Again, we thank you for the opportunity to bring forth our request for a Development Variance Permit for our existing retaining wall at 7665 Cerulean Drive.

We are proposing changes to our existing retaining wall and addressing concerns by our neighbours, 7663; with these changes, it is our hope that council will proceed with approval for our request of a Development Variance Permit.

IMAGE 1:
Moving the top 2 rows
back .06m

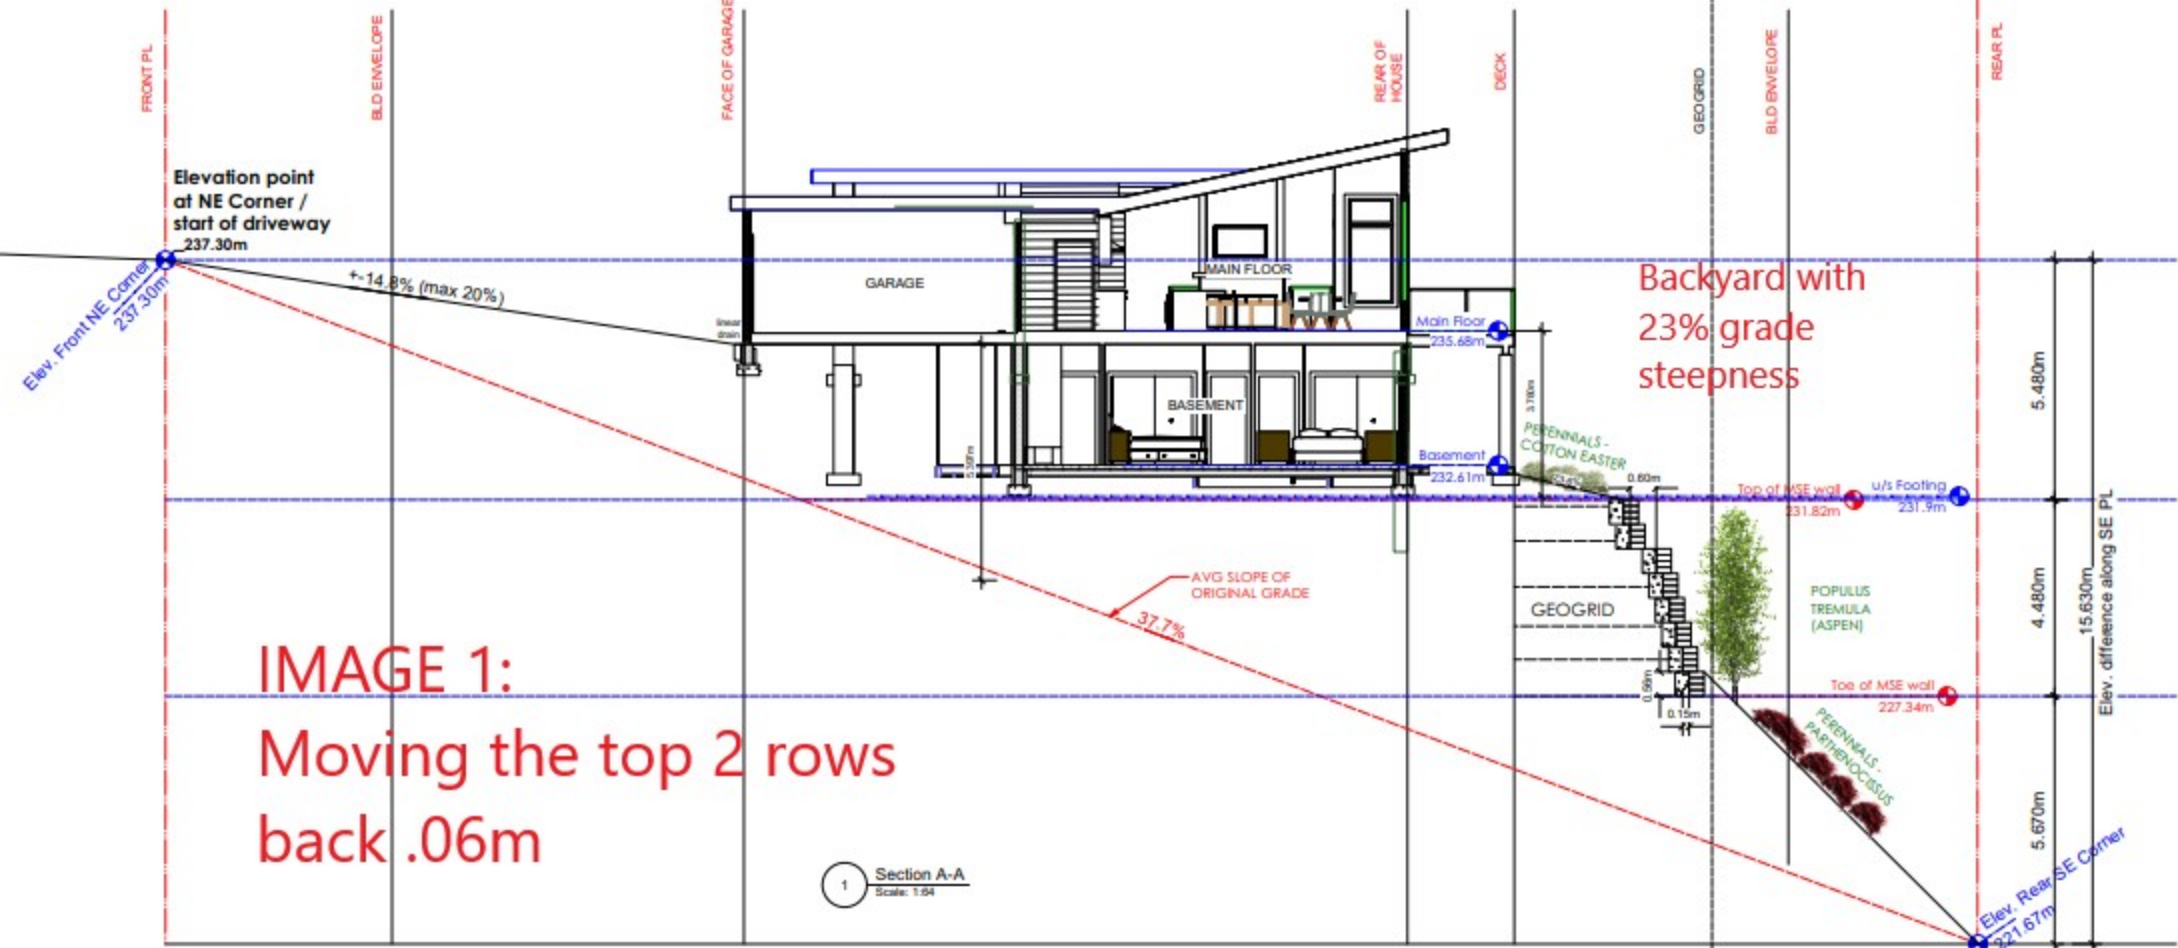
- Image 1: by removing the top two rows of the wall and setting them back .06m as per the Zoning Bylaw 832, 2018, our backyard would host a 23% steepness grade. The landscape plan we have proposed will decrease the visual impact of the wall. Moving the home back further back towards the street will result in a steeper driveway.

IMAGE 2:
 With existing Zoning
 Bylaw. Visually little
 difference.

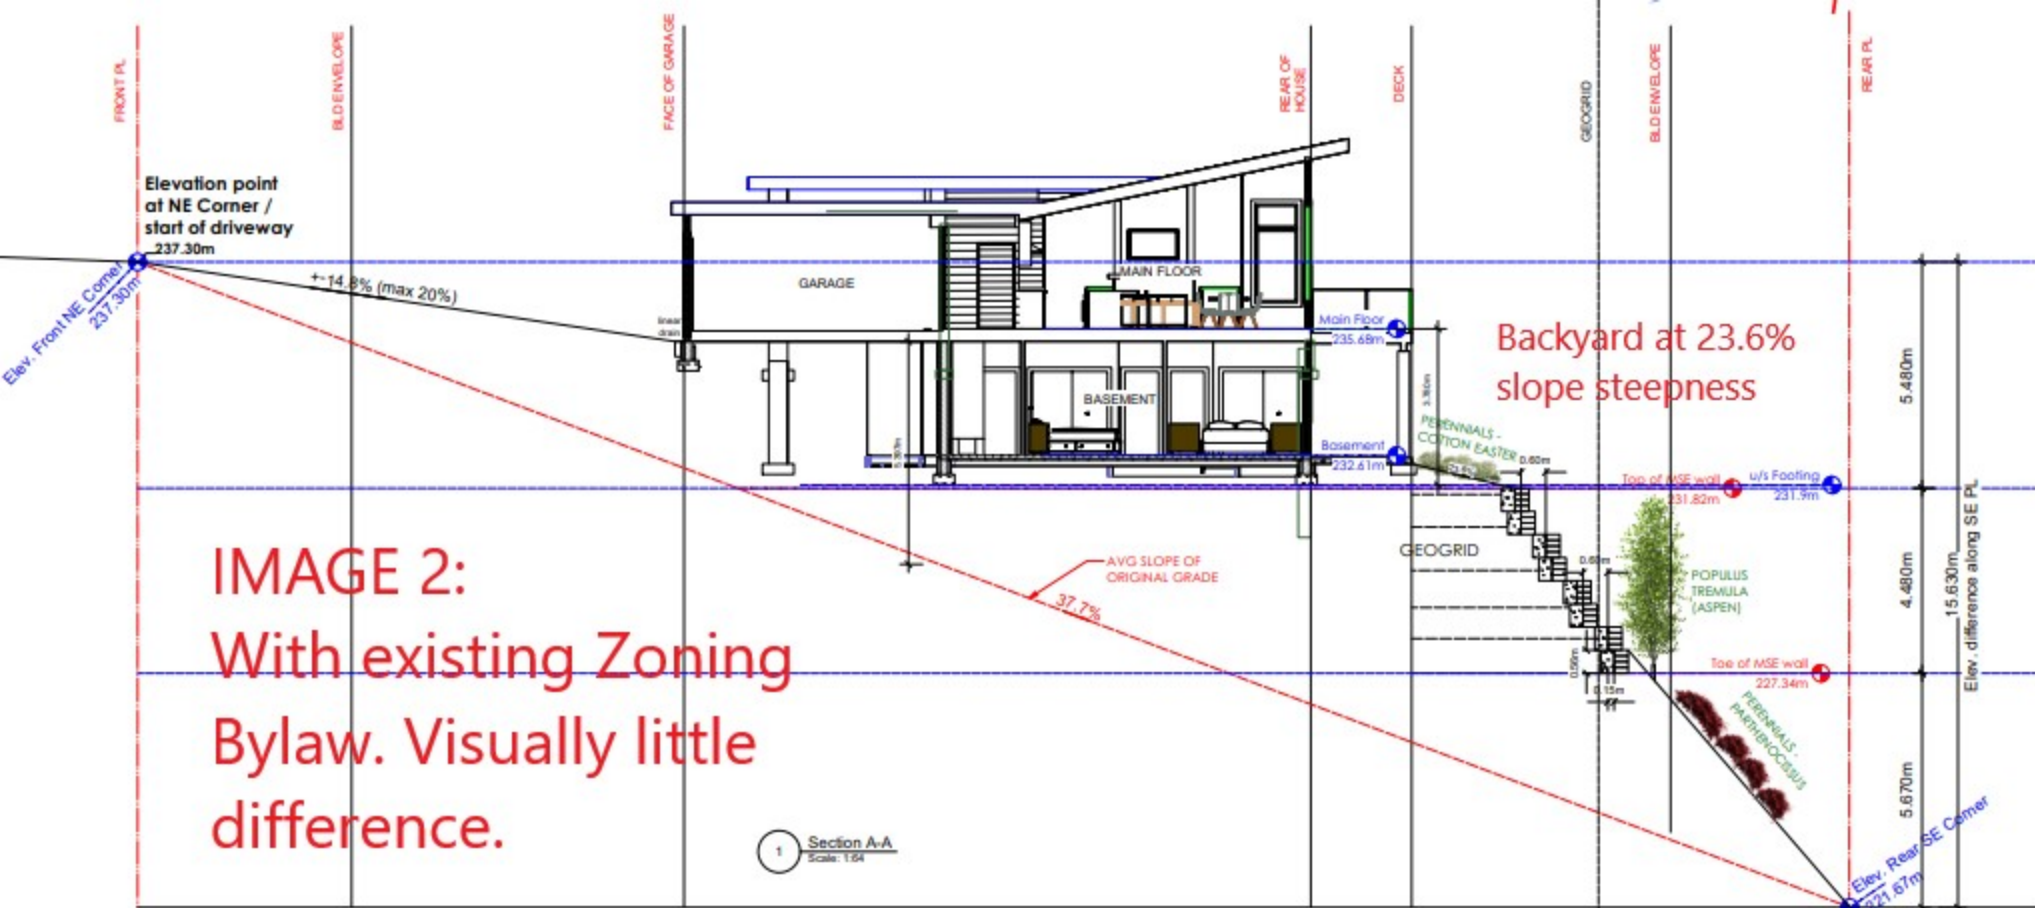
- Image 2: should we had built our retaining wall in accordance with Zoning Bylaw, 832, 2018: there would be very little difference with the visual impact to the front facing view of the retaining wall. The backyard grade steepness would be 23.6%. The driveway would remain at a 14.8% grade. Moving the home back further back towards the street will result in a steeper driveway.
